**REQUEST TO OUTRIGHT VACATE
 THE NORTH/SOUTH & EAST/WEST
 PUBLIC ALLEY IN THE BLOCK BOUND BY
 BRUSH ST., WATSON ST.,
 BEAUBIEN ST. AND WILKINS ST.**

CITY OF DETROIT CITY ENGINEERING DIVISION SURVEY BUREAU	
JOB NO.	01-01
DRWG. NO.	X 1156

NOTICE OF PROPOSED CHANGE IN PROPERTY

Petition: x1156

Comcast
(Utility or City Department)

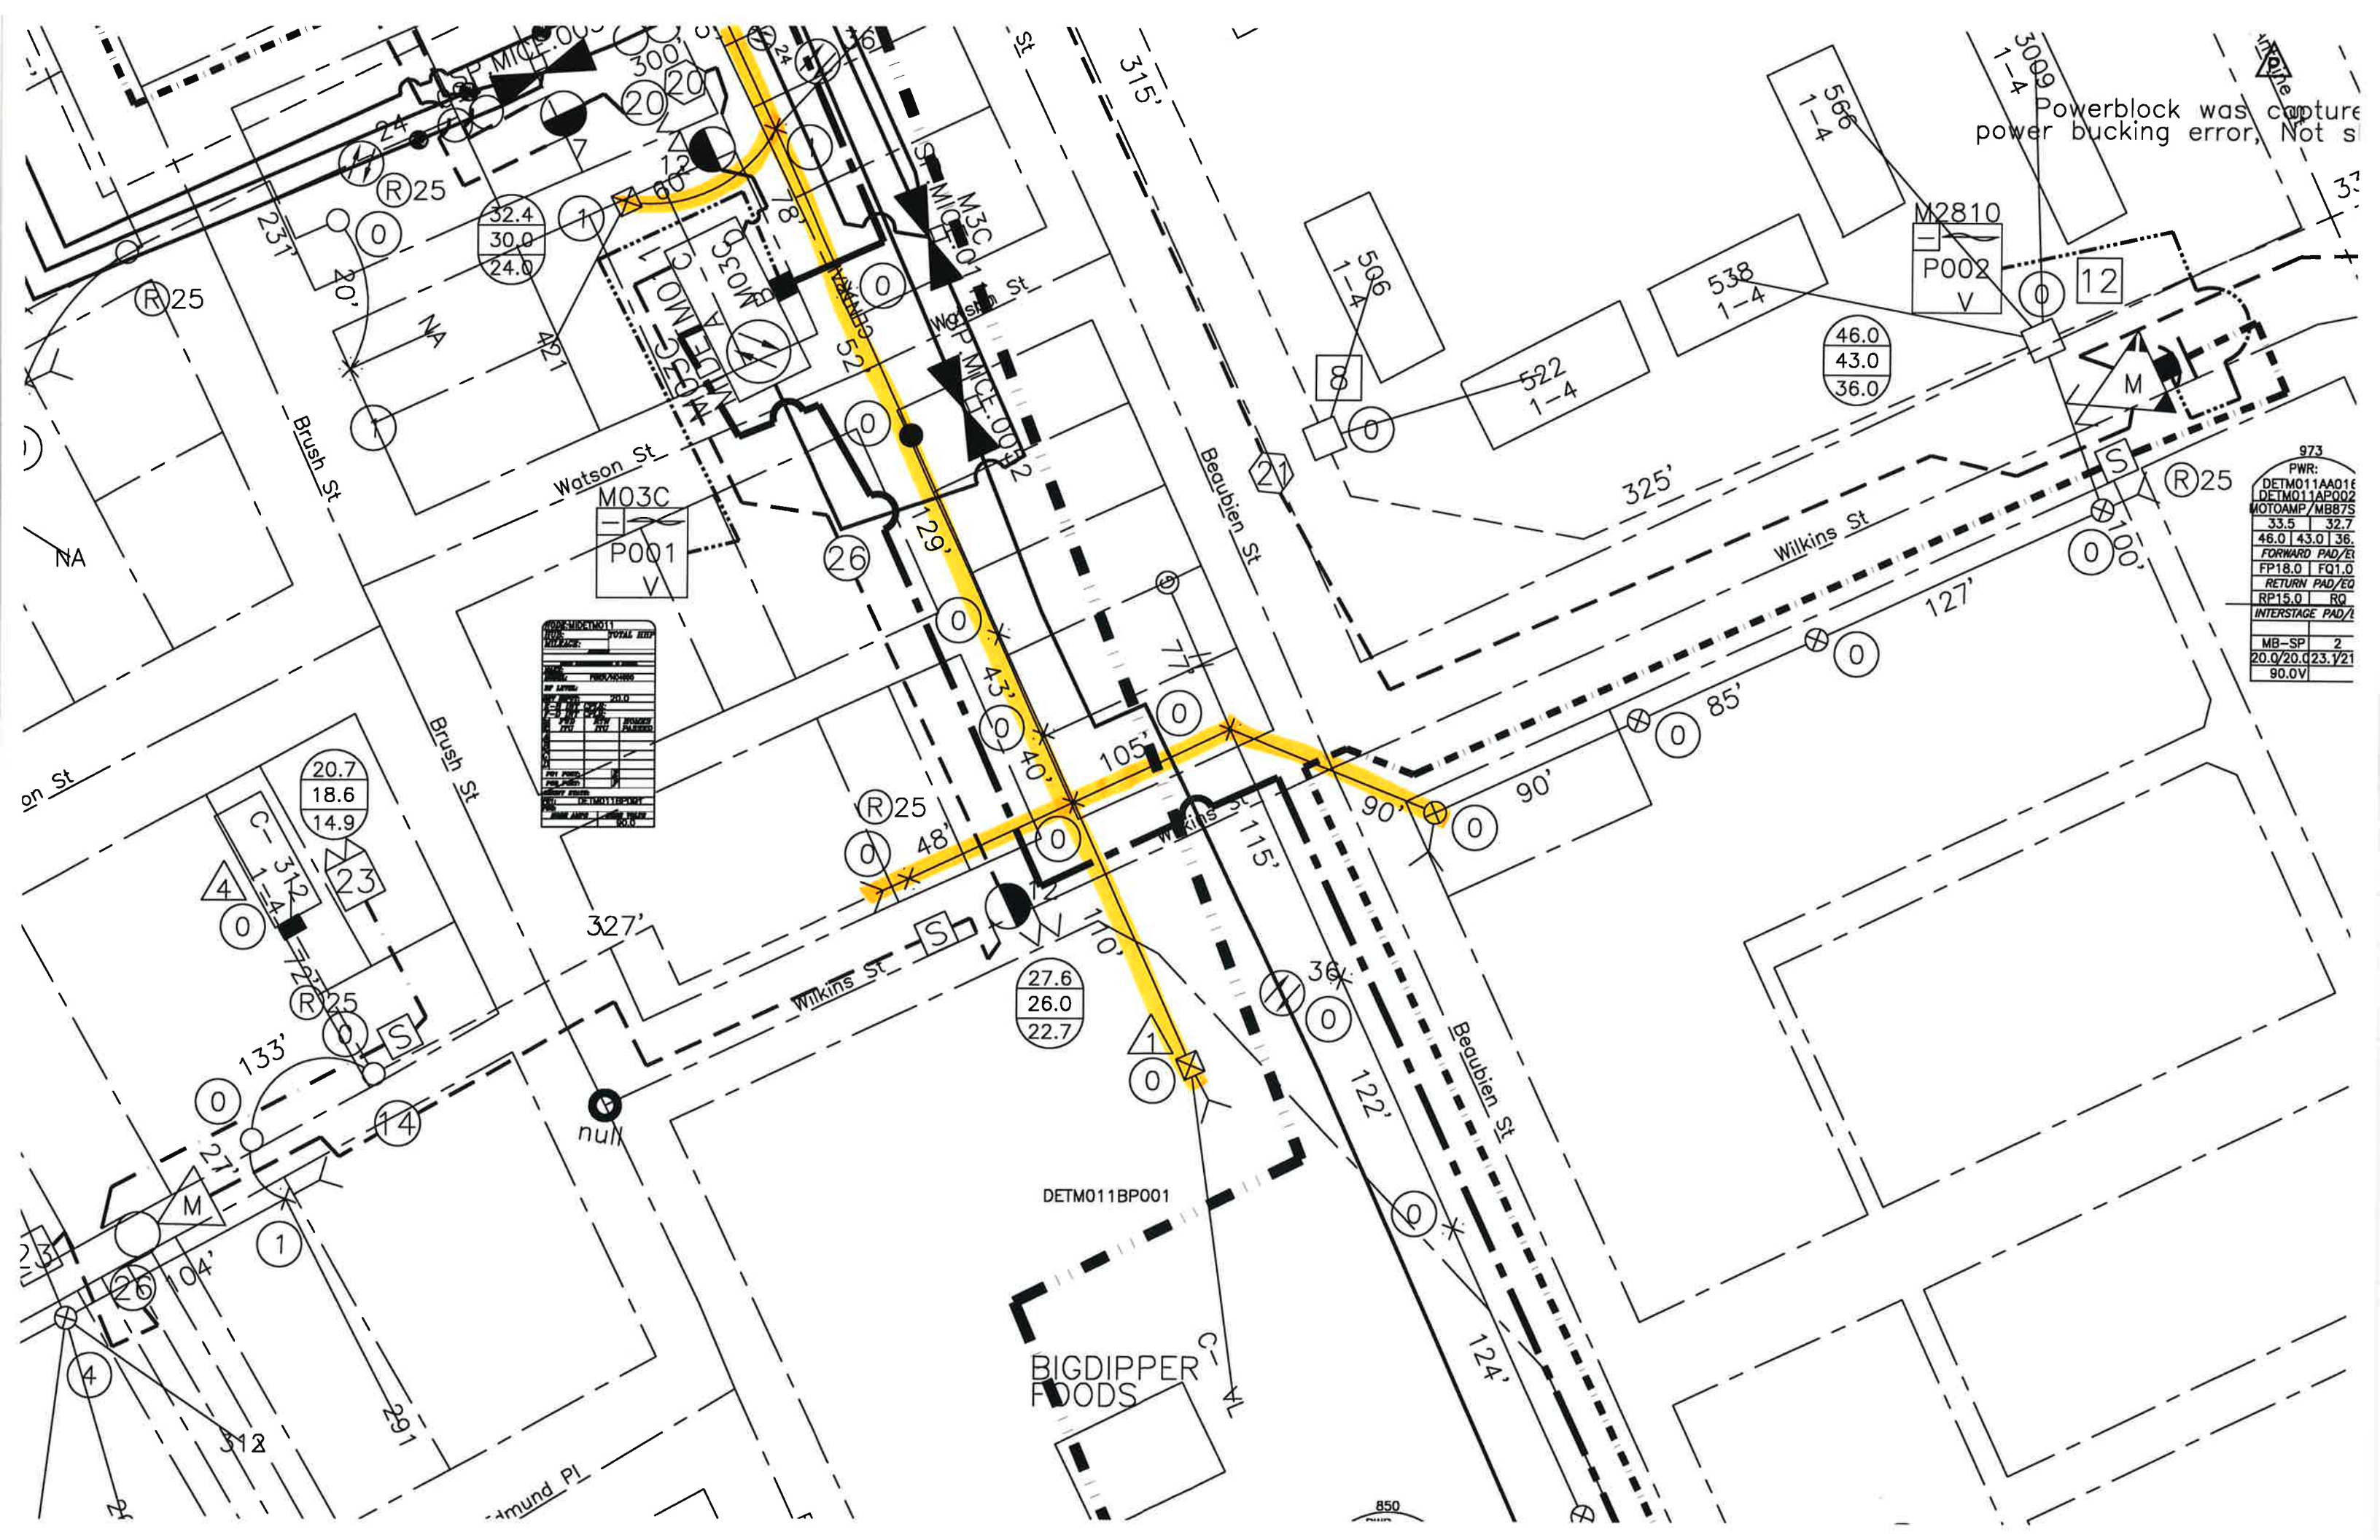
Pleas see attached for cost estimate and payment process
